Report of Staff Recommendation

File No.: 6-C-22-TOB

Applicant: ICON APARTMENT HOMES, PHASE II

TTCDA REVIEW PLANS FOR ICON APARTMENT HOMES AT HARDIN VALLEY PHASE II

SHEET TITLE:
PHOTOMETRIC
SITE PLAN

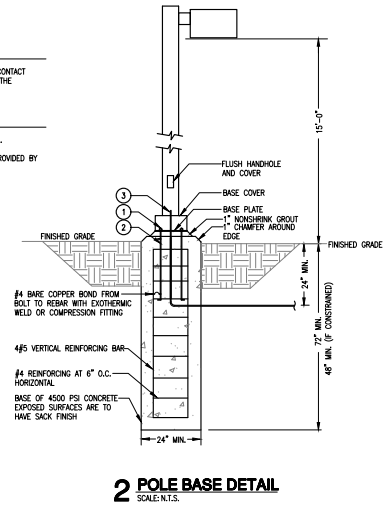
- a. Increase the lighting levels in parking areas from 2.5 fc to 5.6 fc. Staff supports approval of this waiver since the overages occur directly beneath light poles in centralized locations to minimize trip hazards, provide additional safety for drivers and pedestrians, and increase security.

- b. Increase the lighting levels within driveways and streets from 0.5 fc to 2.4 fc at the roundabout. Staff supports approval of this waiver to increase safety for drivers and potential pedestrians.

- c. Increase the lighting level at the sidewalk near the roundabout and Building N from 1.0 fc to 6.0 fc and along paths and sidewalks generally to 1.6 fc. Staff supports approval of this waiver to minimize trip hazards and provide additional safety for pedestrians.

- d. Increase the lighting levels within 20 feet of a residential zone at the amenity area on the southwestern property line from 0.2 fc to 1.2 fc. This overage occurs in an amenity area near Building C11. Staff supports approval of this waiver to provide additional security and safety since the overage occurs in a contained area and existing vegetation in this portion of the site is to remain in place and will provide buffering and screening of the lighting for the adjacent properties.

Per the attached photometric plan, there are a handful of areas, mainly concentrated around the landscaped greenspaces within the parking lots, that exceed this lighting guideline. These areas are expected to draw additional pedestrian traffic including pet-walking. The additional lighting is needed to increase security and minimize trip hazards. These areas are centralized in the property and it's not anticipated there will be any impact to adjoining properties.

Residential zone. There are a handful of locations where the lighting intensity exceeds 0.2 within 20-feet from a residential property line (ranging from 0.3 to 1.3). The majority of these exceeding areas are adjacent to planned outdoor amenities and common-areas. Those areas are expected to attract heavy pedestrian activity and the additional lighting is required for increased security, safety, and to minimize trip-hazards. These areas will also be shielded from the adjoining property with landscaping, and the lighting at the property line will be between 0.0 fc and 0.1 fc. Further north from this common area there are 8 areas where the light intensity ranges from 0.3 to 0.7. This is adjacent to a sidewalk where the additional lighting intensity is needed for increased security and safety. As with the amenity area, the lighting intensity is reduced to 0.0 to 0.1 at the property line.

The lighting intensity on the streets and driveways within the development ranges from 0.3 to 2.2 fc. A waiver is requested for the lighting intensity to allow up to 2.2 fc as depicted on the photometric. The internal driveways connect various building areas which are on different topographical planes along the property, and which connects the planned Phase II with the current Phase I. These driveways must curve as they follow the existing topography. While there are internal sidewalks along these driveways, the additional lighting further promotes safety and helps minimize pedestrian, pet, or wildlife conflicts with traffic on the driveways. This additional lighting is not anticipated to have a negative impact on the adjoining properties as the anticipated lighting intensity along the property line is projected to be between 0.0 and 0.1 fc.

- 1) Increase the floor area ratio (FAR) from 30% to 33.7%. Staff supports approval of this waiver since the overage is minimal.
- 2) Increase the lighting levels in parking areas from 2.5 fc to 5.6 fc since the overages occur directly beneath light poles in centralized locations to minimize trip hazards, provide additional safety for drivers and pedestrians, and increase security.

- 3) Increase the lighting levels within driveways and streets from 0.5 fc to 2.4 fc at the roundabout to increase safety for drivers and potential pedestrians.

- 4) Increase the lighting level at the sidewalk near the roundabout and Building N from 1.0 fc to 6.0 fc and along paths and sidewalks generally to 1.6 fc to minimize trip hazards and provide additional safety for pedestrians.

- 5) Increase the lighting levels within 20 feet of a residential zone at the amenity area on the southwestern property line from 0.2 fc to 1.2 fc to provide additional security and safety.
